Subject: Corrections / Clarifications to the Exelon Generation company, LLC  
(EGC) Early Site Permit (ESP) Application Site Safety Analysis Report  
and Emergency Plan for the Clinton ESP Site (TAC No. MC1122)

Corrections / Clarifications to the Site Safety Analysis Report of the EGC ESP

**EGC REVISION ID: E1-1**

**Figure 2.4-2**  
**Plan of Main Dam, Spillways,**  
**and Outlet Works**

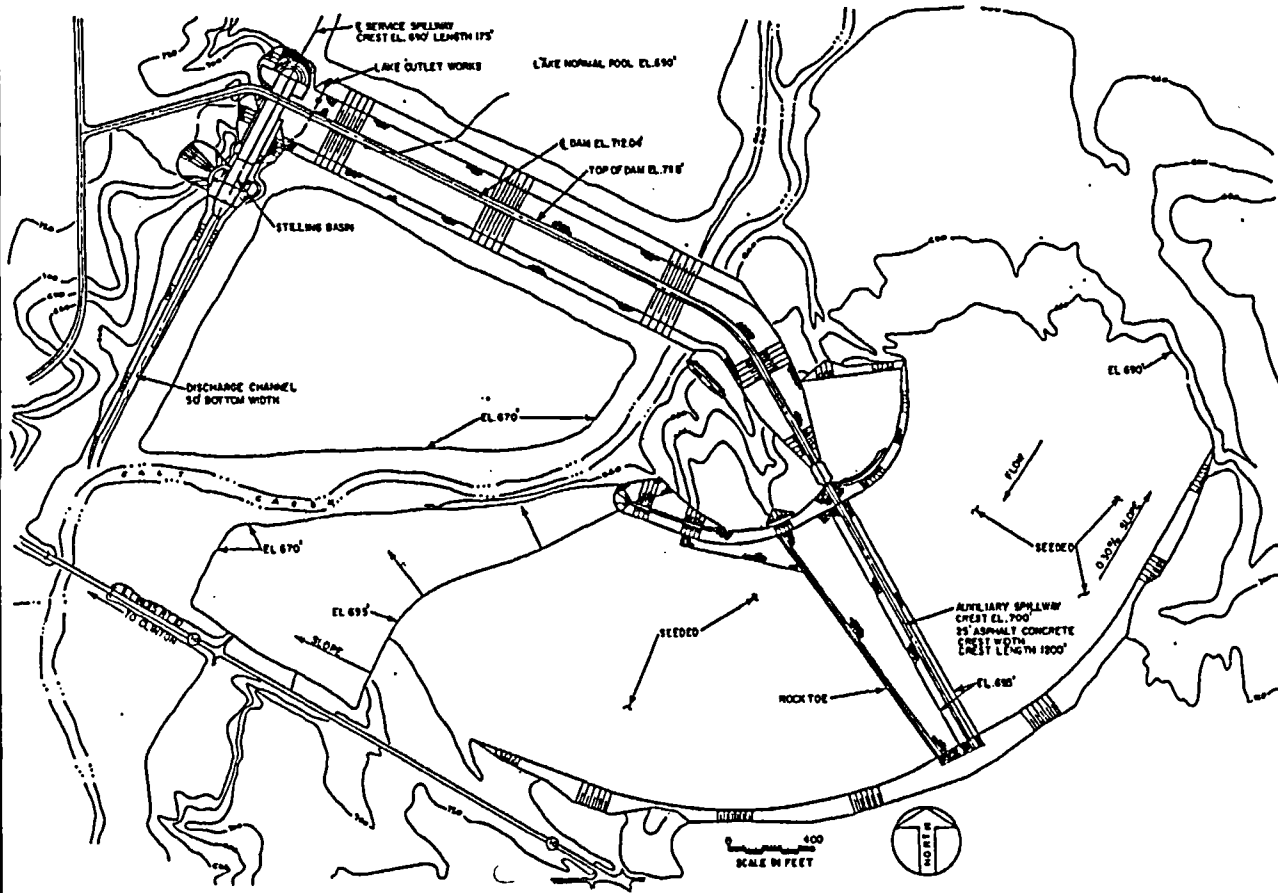
SSAR Figures 2.4-2, 2.4-10, 2.4-11, 2.4-12, 2.4-14 and 2.4-15 were revised to improve the legibility

*1. Replace SSAR Chapter 2, Figures 2.4-2, 2.4-10, 2.4-11, 2.4-12, 2.4-14 and 2.4-15 with the revised figures provided in Attachment 1.*

Figure 2.4-20

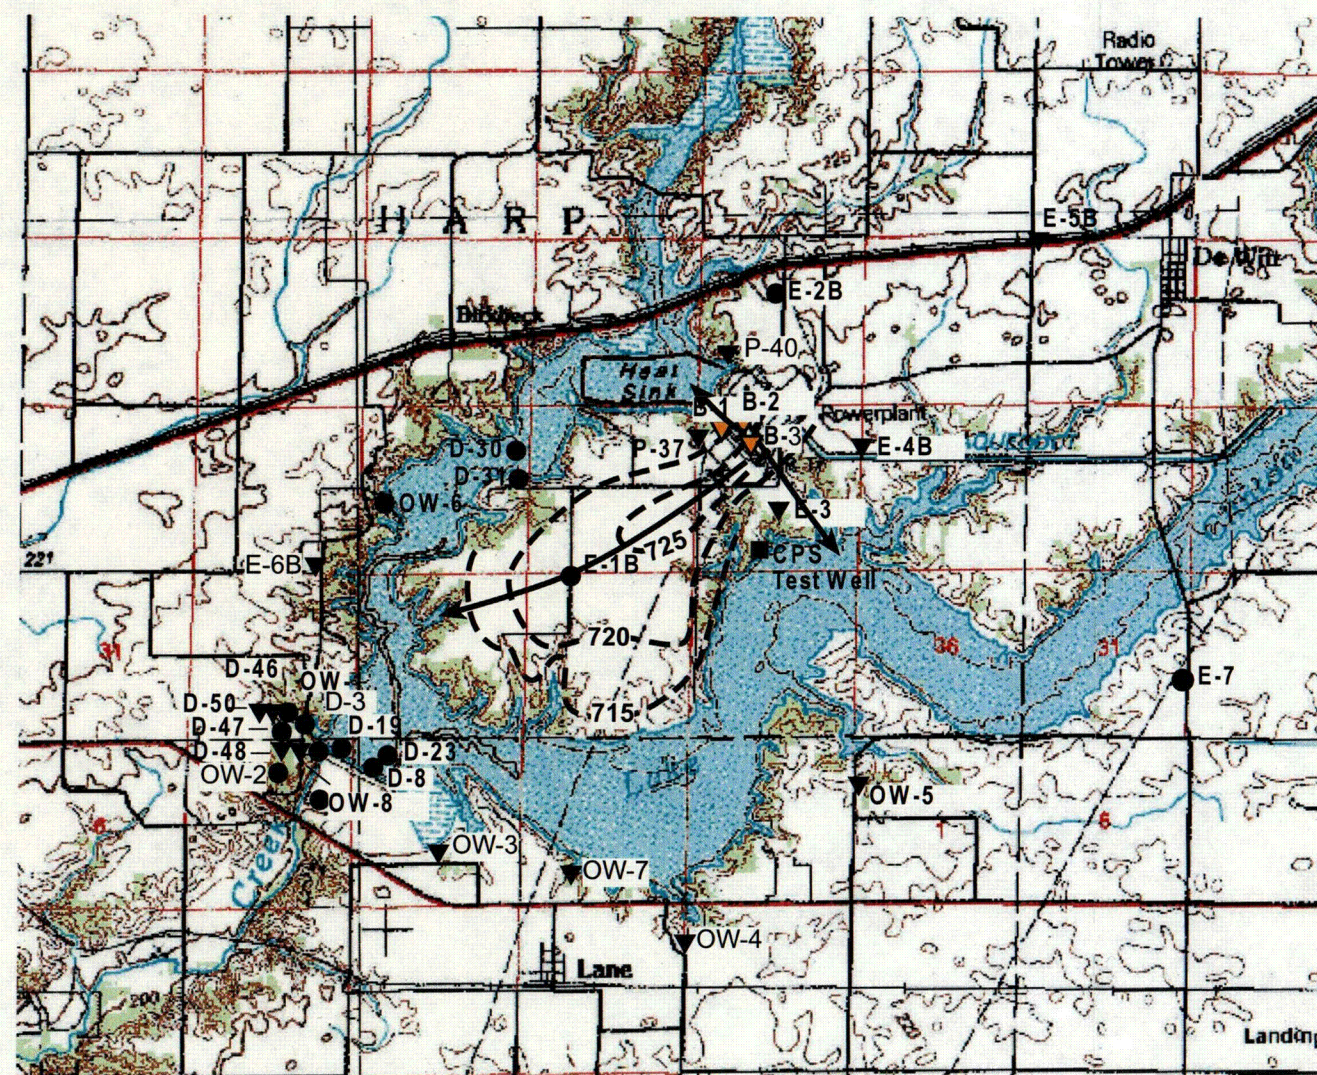
Water table elevations shown on the Figure 2.4-20 are incorrect (not consistent with the flow arrow). Elevations on figure will be modified by switching the "715" and "725" contour levels.

- 1. Replace SSAR, Chapter 2, Figure 2.4-20, with the revised figure provided in Attachment 1.*

Site Safety Analysis Report for  
the EGC Early Site Permit  
**Figure 2.4-5**  
**Post-dam Peak Flood**  
**Magnitudes and Frequencies for**  
**Salt Creek at Rowell Gauge Station**

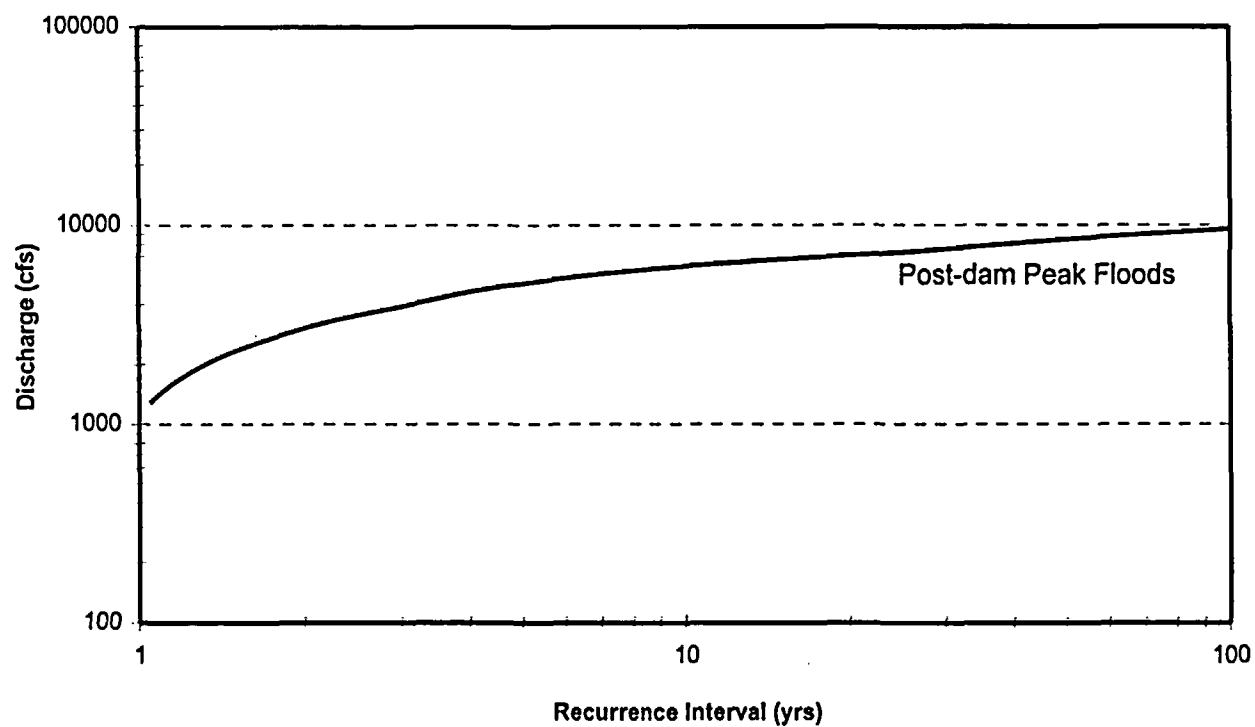
The flood frequency estimations for the Rowell gauge were re-examined (based on discussions with the NRC during their site visit and the draft RAIs where they noted discrepancies with the discharge data) resulting in an update of the statistical analysis of the historical discharge data at the Rowell gauge. First, the period of record for the historical data was updated to include Water Years 1979 through 2003. Second, the latitude and longitude of the input to the USGS DOS-based program (Peak FQ) which is the Log Pearson Type III analysis as described in WRC Bulletin 17B was revised to more closely reflect the location of the gauge. Additionally, a note is added to SSAR Figure 2.4-5 (for clarification) which reads: "Note: Based on daily mean discharge values."

3. *Replace SSAR, Chapter 2, Figure 2.4-5, with the revised figure provided in Attachment 1.*

**NOTE:**  
*Based on daily mean discharge values.*

**Figure 2.3-2  
ESP EPZ Permanent  
Population by Radial Grid Sector**

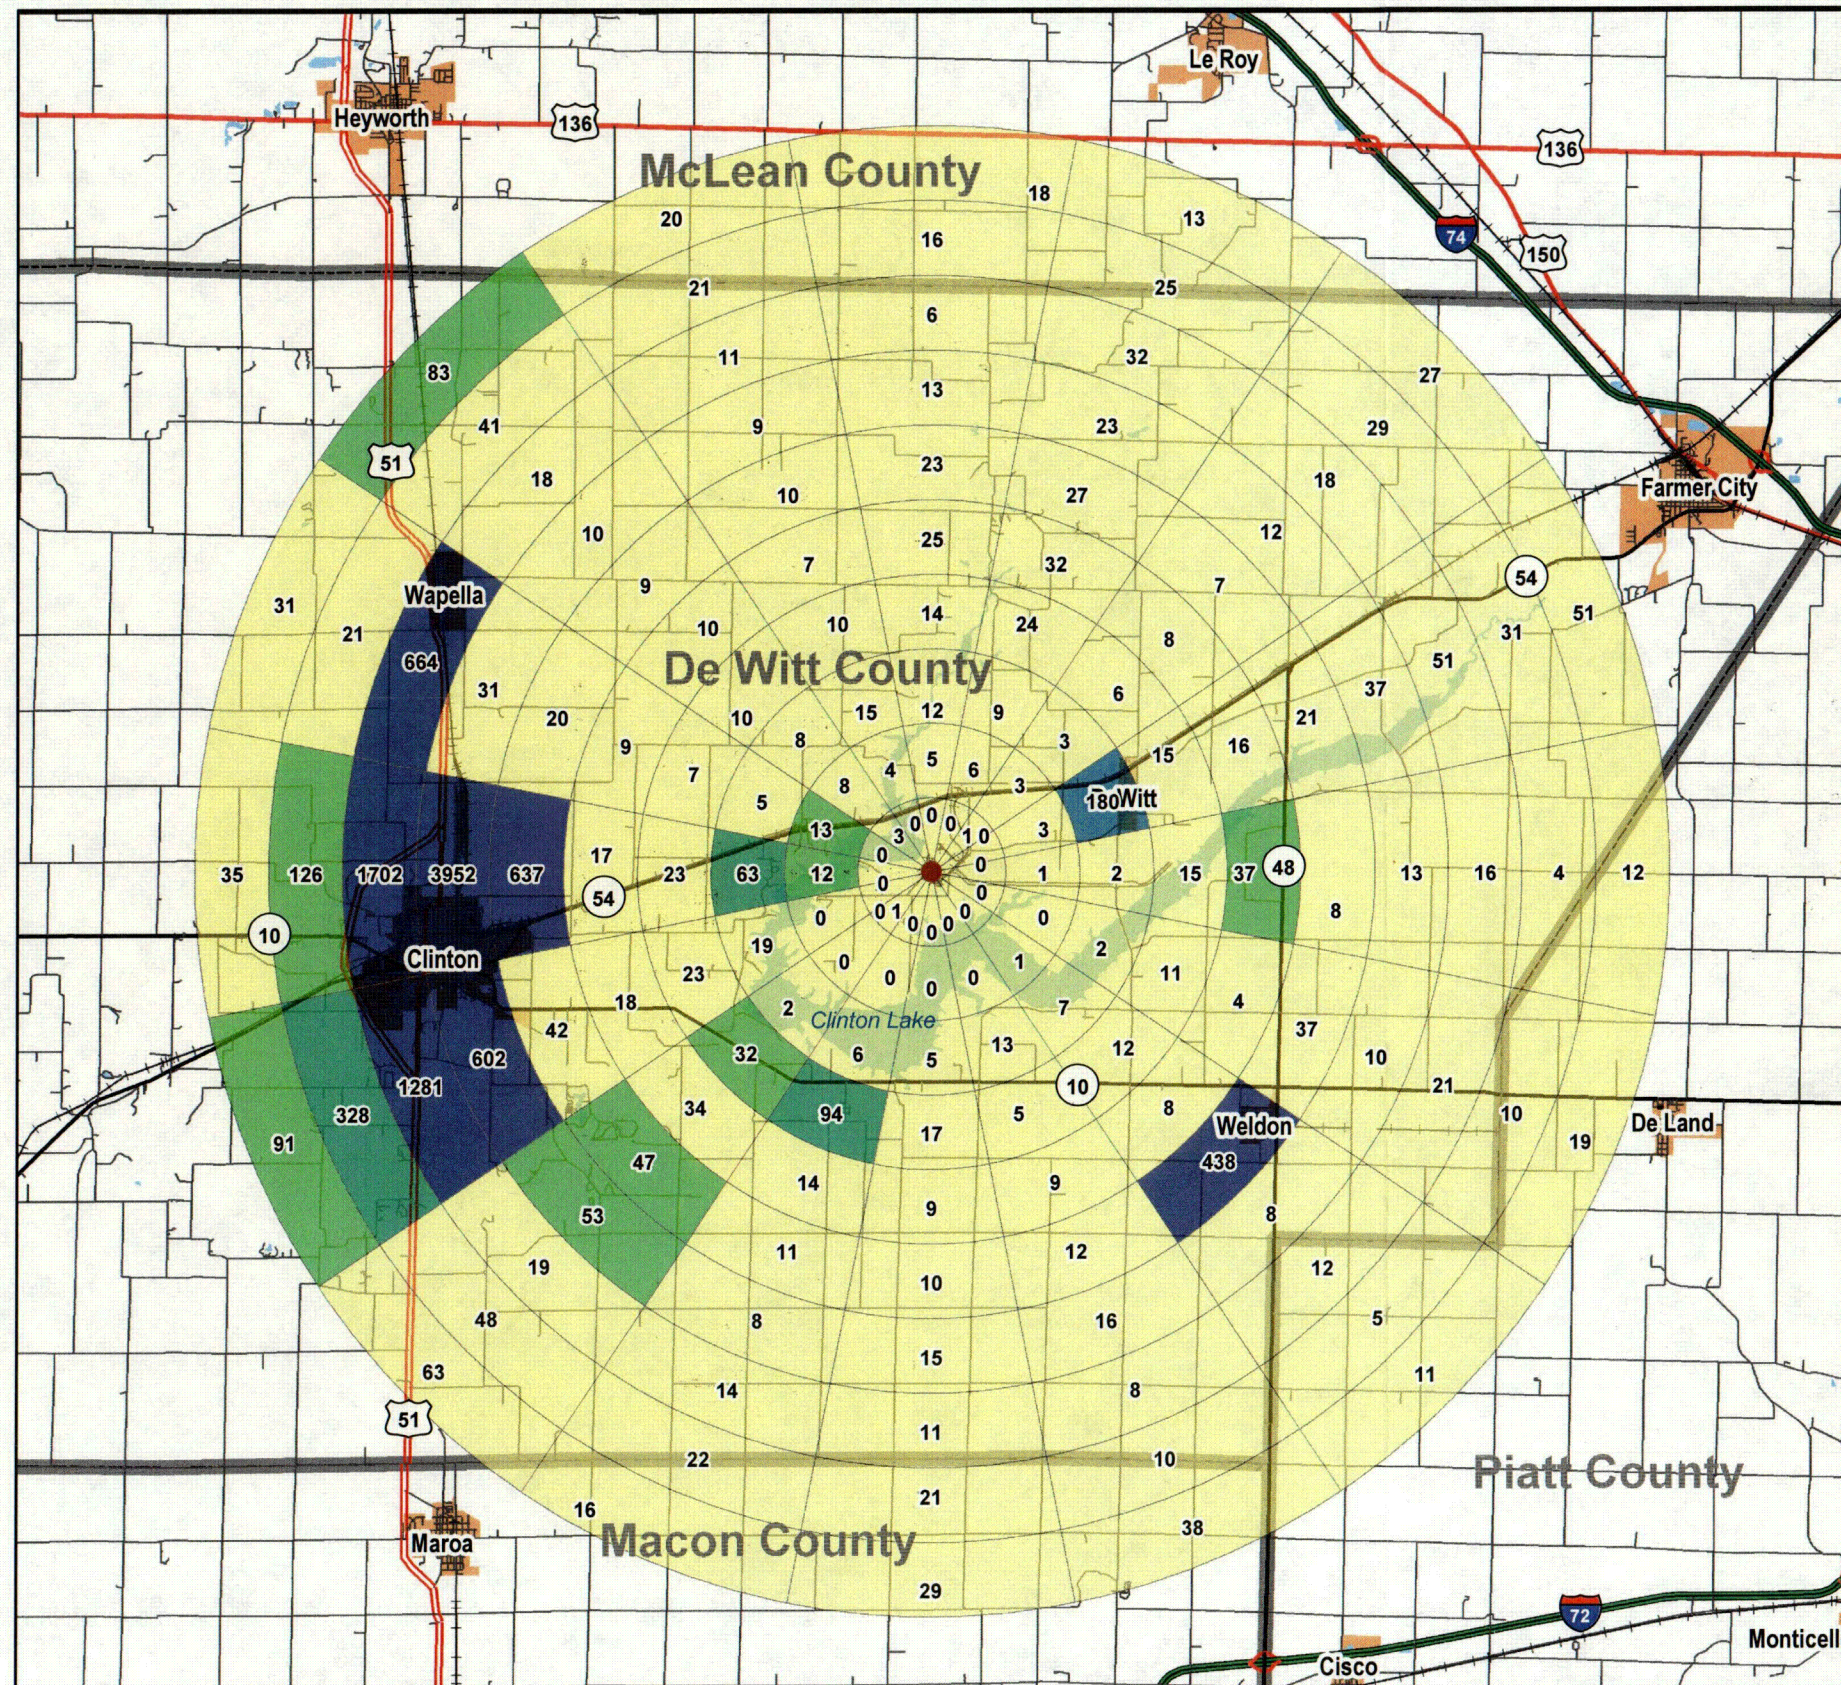
Total population column in Table 2.1-1 has been corrected to reflect the total. In addition, Figure 2.3-2 is also corrected since the data in the figure is taken from Table 2.1-1.

*Replace EP, Chapter 2, Figure 2.3-2 with the revised figure provided in Attachment 1.*
